Center for Jewish Living: Preliminary Plan No. 120140090

Staff Report Date: 10/17/2014

Request to create one lot for a religious institution and weekday childcare from an existing lot and a parcel, located on the west side of Georgia Avenue (18320-18326 Georgia Avenue), approximately 1,500 feet north of the intersection with MD 108, 1.65 acres, R-200 Zone, 2005 Olney Master Plan

Staff Recommendation: Approval with conditions

Attachment A - Preliminary Plan

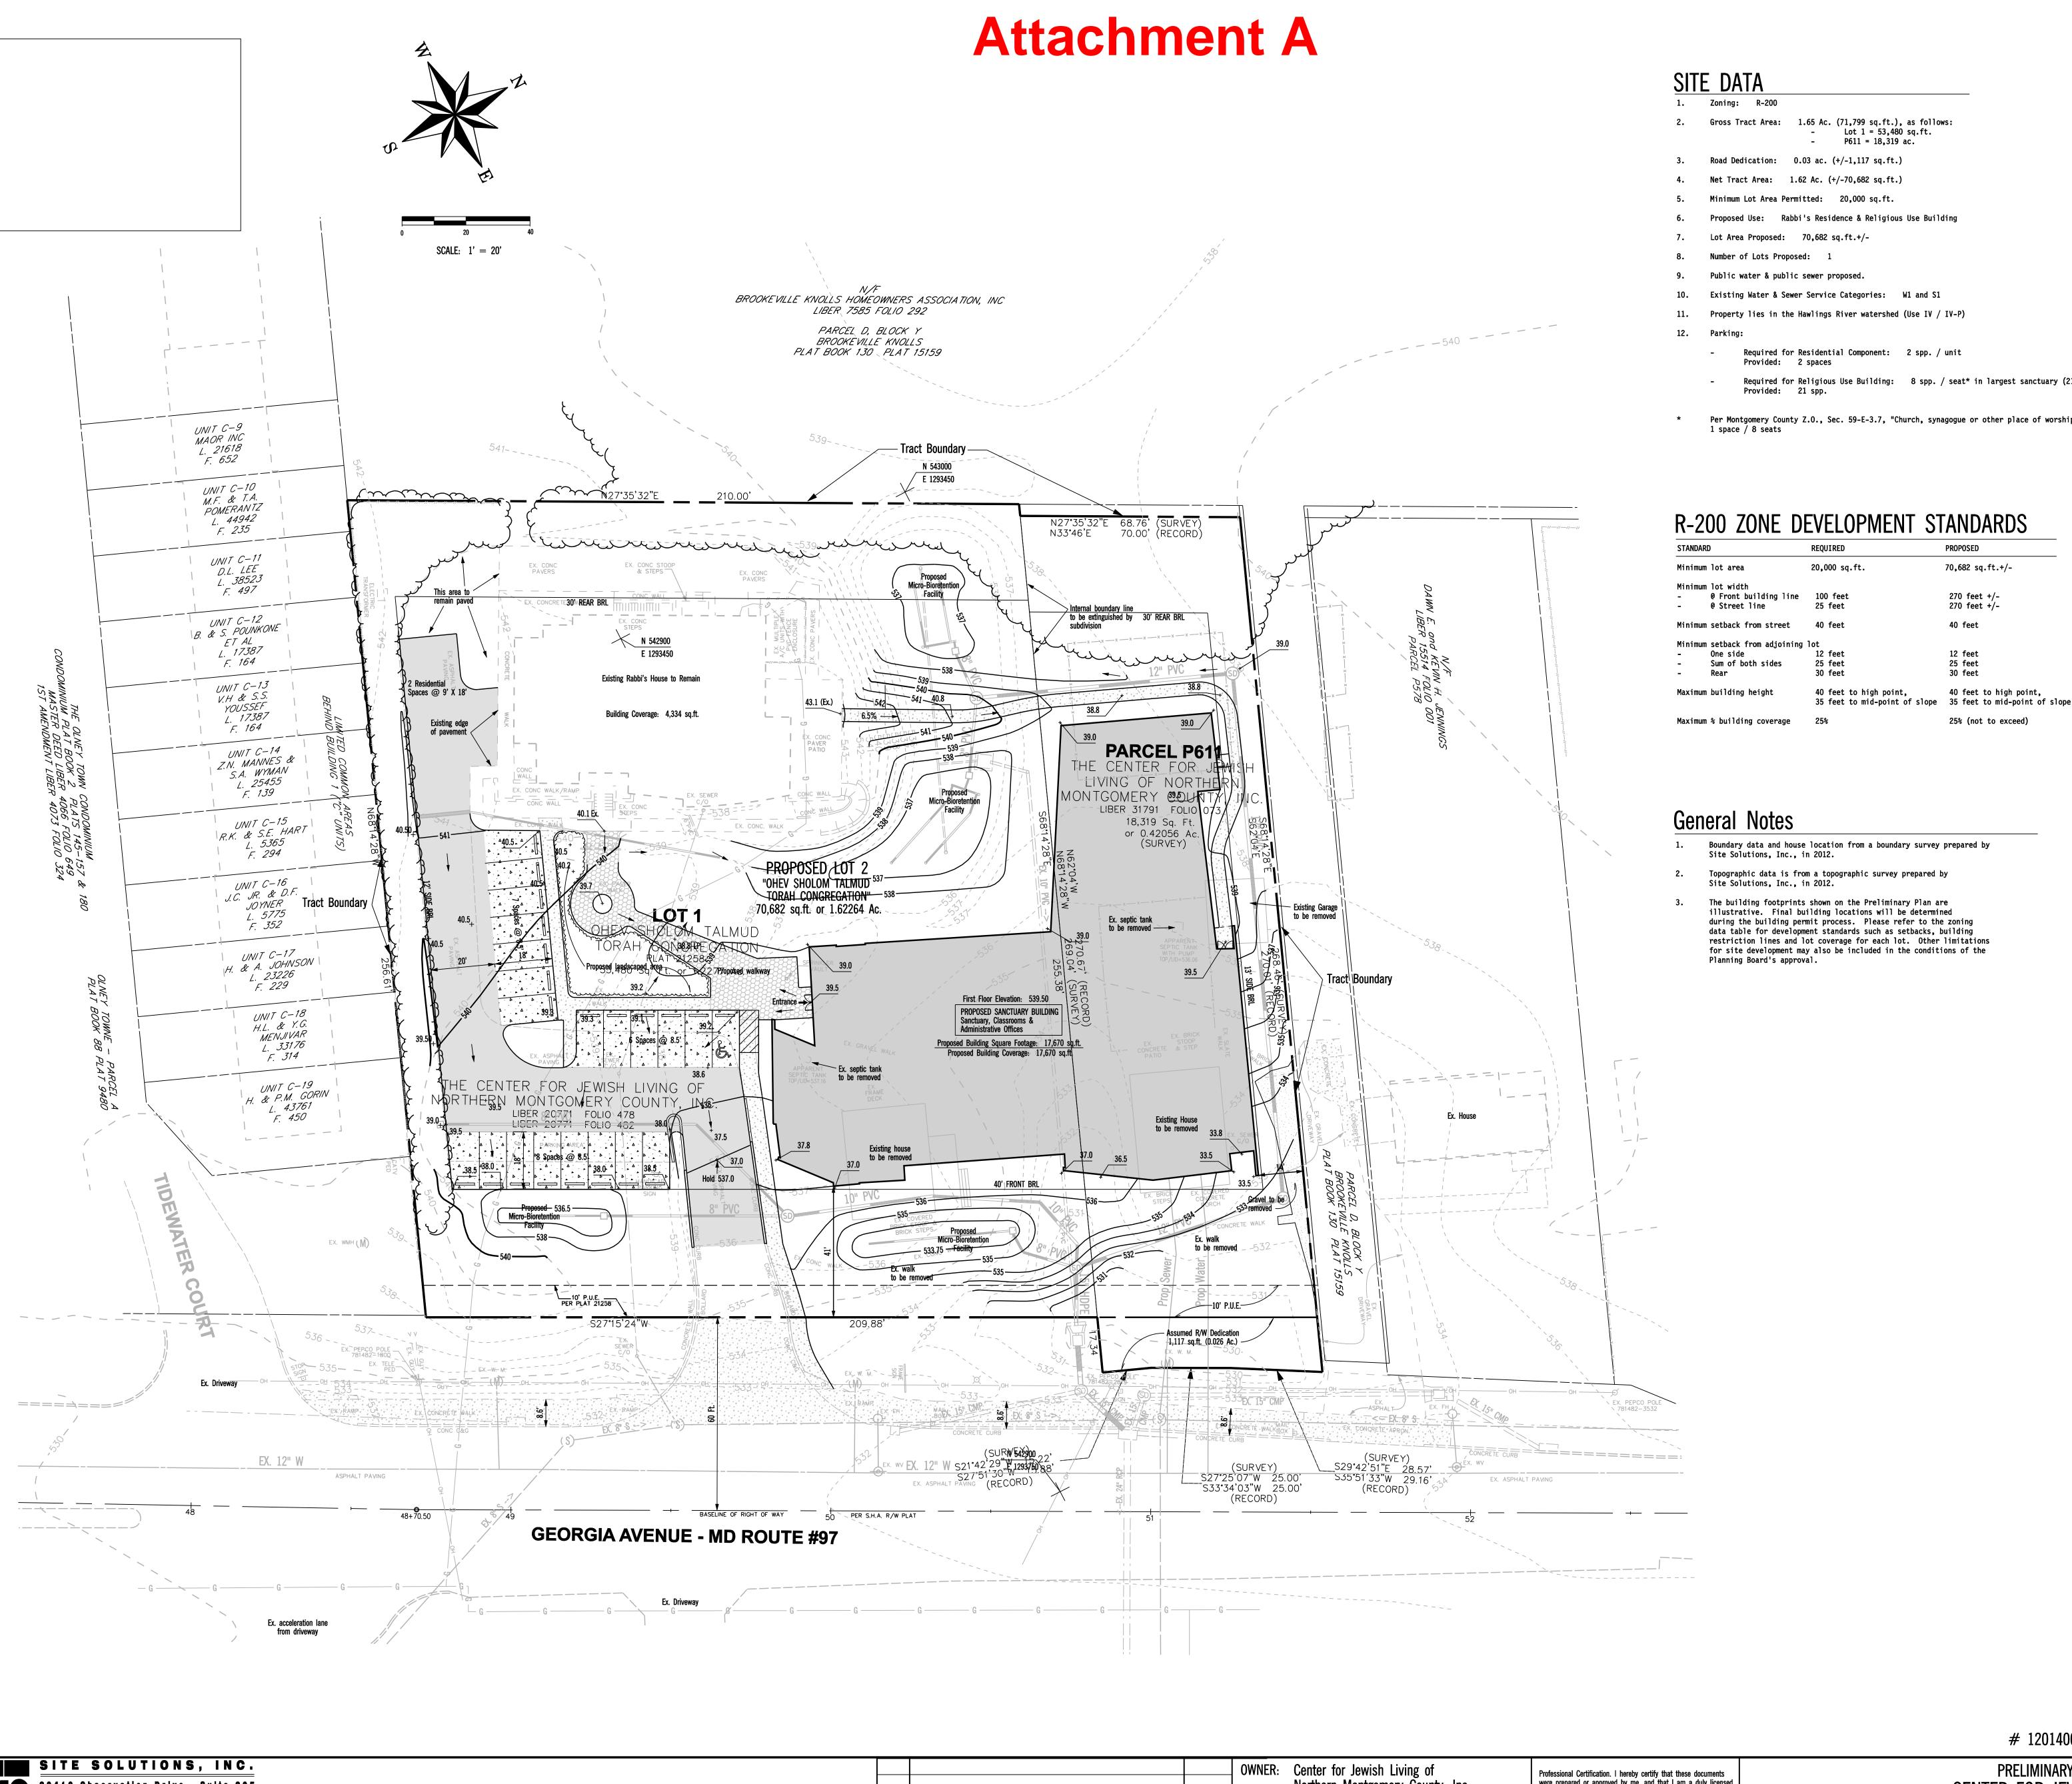
Thank you for the opportunity to review the preliminary plan, dated February 4, 2014, for the proposed Center for Jewish Living development in Montgomery County. The State Highway Administration (SHA) offers the following comments:

- 3. Please provide a sight distance evaluation using the attached sight distance evaluation form. Once completed, the form should be stamped and certified by a Professional Engineer.

- 4. Please verify that the existing sidewalk and ramps along the frontage of the property meets current ADA compliance. For more information on ADA and Bicycle compatibility, please see the following links: http://www.roads.maryland.gov/OHD2/Bike Policy and Design Guide.pdf.

- 5. The installation of the proposed water line and sewer house connections within SHA right of way must conform to the conditions of a SHA Utility Permit. The developer or engineer must submit a copy of the utility drawings to the SHA District 3 Utility Engineer for comments. The drawings must show any necessary road repairs required in the Permit. Please refer to our website www.roads.maryland.gov under Business Center, Permits, Access Permits for more information about District Office Permits. You may also contact Mr. Victor Grafton at 301-513-7350, by using our toll free number in Maryland only at 1-800-876-4742 or via email at vgrafton@sha.state.md.us.

- 6. Based on the Olney Master Plan, the 1,117 square feet area of dedication shown on the plans will be required. The State Highway Administration requires that any right-of-way or easement donation (dedication) be platted to SHA standards. These standards may be found at http://www.roads.maryland.gov; Business Center; Surveyors Center; then follow the link to Developer Donation Plat Standards. Please contact Ms. Jane Heming, Chief, Records & Research Section, Office of Real Estate at 410-545-2829 or iheming@sha.state.md.us for existing right-of-way information. Note that any plats produced for the SHA shall be on NAD83/91 datum. Please contact Mr. Dan Sain, Assistant Division Chief, Plats and Surveys Division at 410-545-8961 or dsain@sha.state.md.us for SHA-GPS control location and information. All

We have completed our review of the preliminary plan dated February 3, 2014. This plan was reviewed by the Development Review Committee for its March 7, 2014 meeting. We recommend recommendation approval for the plan subject to the following comments:

- 6. Denote the existing sidewalk width along Georgia Avenue.
- 7. Show all driveways adjacent and opposite the site on the plan.
- 8. The parking layout plan will be reviewed by the Department of Permitting Services at the site plan or building permit stage, whichever comes first. To facilitate their review, that plan should delineate and dimension the proposed on-site travel lanes, parking spaces, curb radii, handicap parking spaces and access facilities, and sidewalks. The applicant may wish to contact Mr. Sam Farhadi of that Department at (240) 777-6333 to discuss the parking lot design.

- 11. Where perpendicular parking spaces border a sidewalk, a two (2) foot vehicle overhang is assumed. The applicant should either provide a seven (7) foot wide sidewalk or wheelstops within those parking spaces.

IMPERVIOUS AREA EXHIBIT (Supplement to Preliminary Forest Conservation Plan)

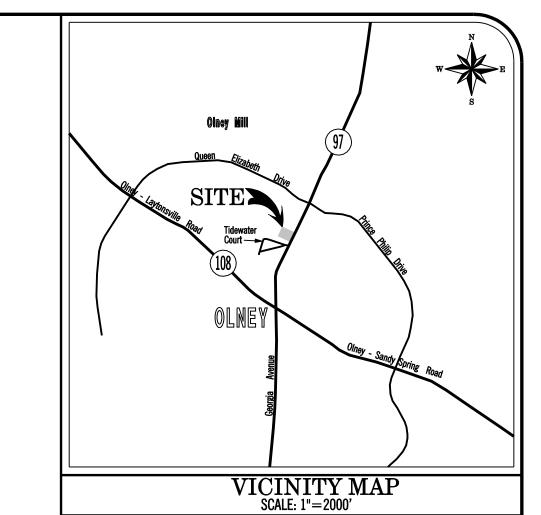
1 Add note that walks to be of permeable pavement
